Modification of Development Consent

Development consent: DA374-11-00 granted by the Minister for Urban Affairs and Planning

For the following: Sunrise Project (formerly known as the Syerston Nickel Cobalt

(DA374-11-00 MOD 7)

Figure 1: Development Components

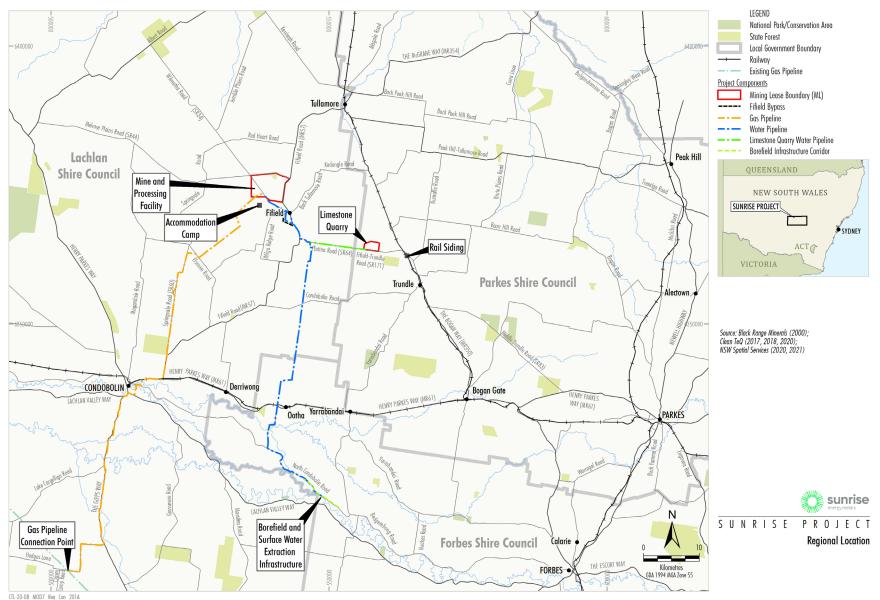
- Lot 1 DP 752077;
 - Lot 1 DP 1144211;
 - Lot 1 DP 1250340;
 - Lot 28 DP 752111;
 - Lot 8 DP 754021; and
 - Lot 24 DP 752089
- 48. In Appendix 2, replace figures 1 to 6, 8, 10 and 11 with the following images in numerical order:

Figure 11: Accommodation Camp Layout

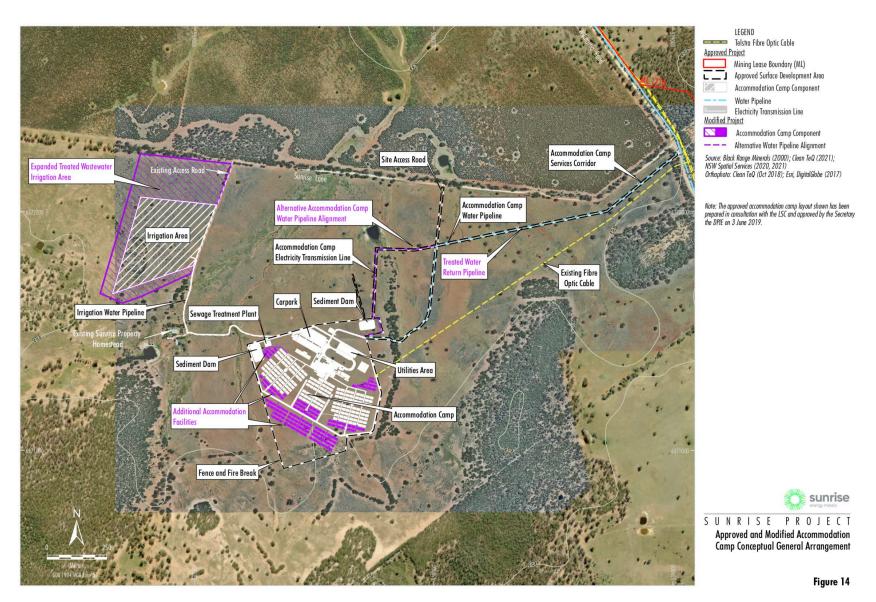
- Limit irrigation to the expanded irrigation area (refer to Appendix 2, Figure 11) to the construction phase only.

Figure 12: Residences surrounding the mine and processing facility

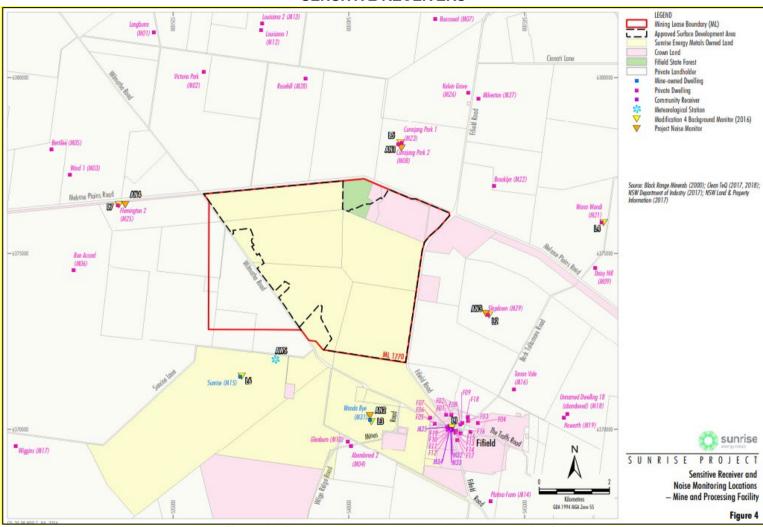
49. Delete the text and figure in Appendix 4, and replace with:
